Re: Re: Site Address: Ward Court, 65 Sea Front, Hayling Island
Proposed Development Form 5 no. Flats at roof level and provide new cladding and render finish to existing building
Your Ref: APP/19/00722

1. The Amended Plan.

2. The Parking Supporting Statement

H.M. LAND REGISTRY		TITLE NUMBER HP58523	
ORDNANCE SURVEY PLAN REFERENCE	SZ7198	SECTION A	Scale 1:1250 Enlarged from 1:2500
COUNTY	HAMPSHIRE	DISTRICT	HAVANT
			© Crown copyright 1976

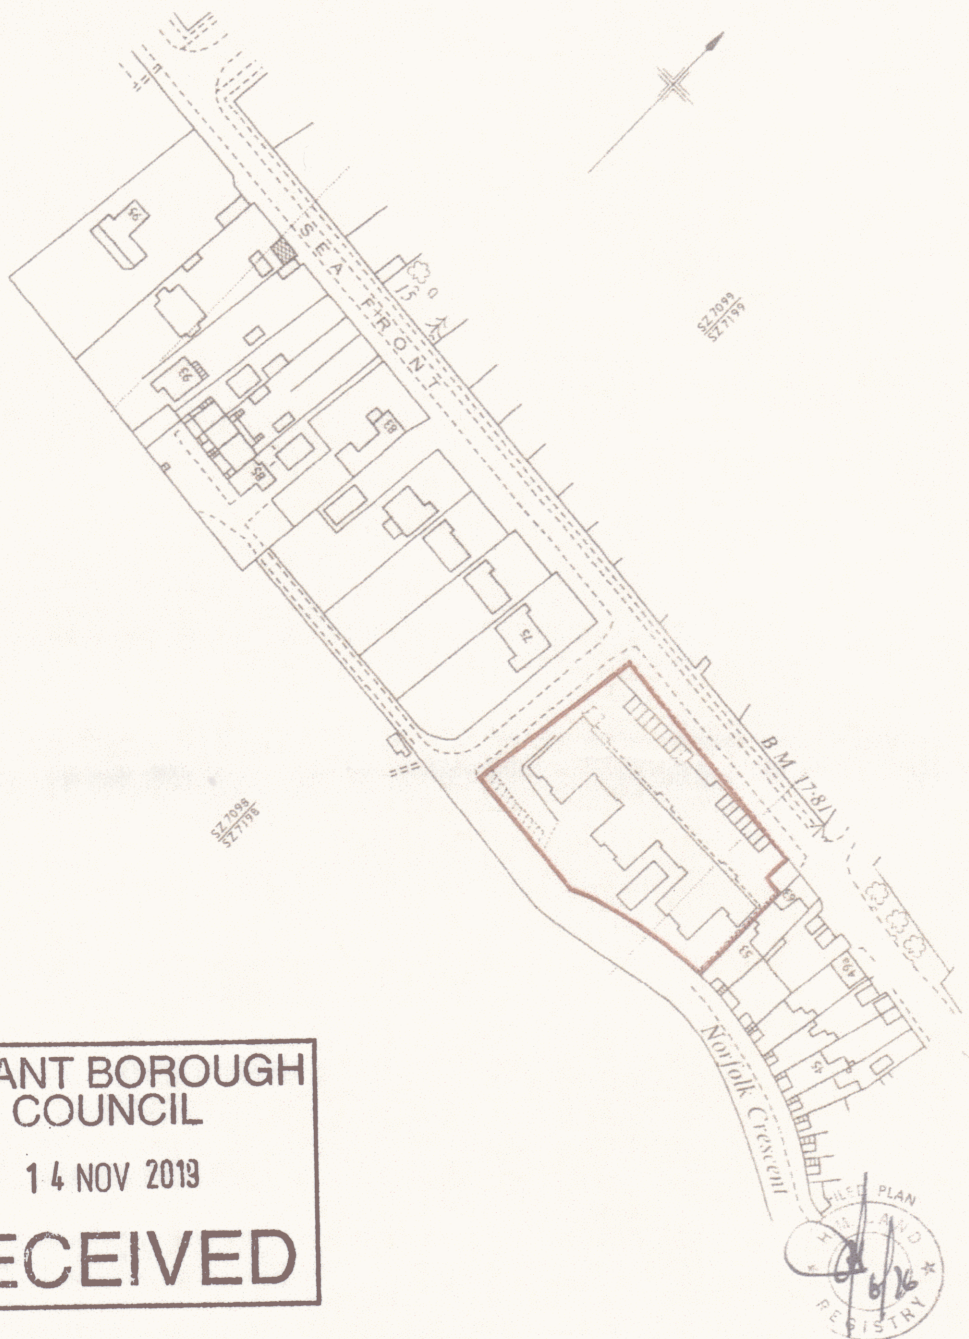
With regard to the remaining spaces outside the boundary wall I enclose the Land Registry file plan of the block from which it will be seen that the 5 spaces to the east of the entrance are not owned by the block. Part of this area is actually highway. Ownership of some of the 11 (not 10) spaces to the west of the entrance is also questionable because the boundary cuts diagonally across them. The applicants have placed signs on the wall all the way around the northern and western walls of the block threatening penalties to persons parking without a permit and has issued "permits" to residents to park in these areas. The applicants refuse to issue more than 2 permits per flat and employ a parking ticket company to issue tickets to residents or others whose cars are parked without a permit, even though with regard to the spaces to the east of the entrance, and the unadopted road on the west side of the block they have no right to do so.
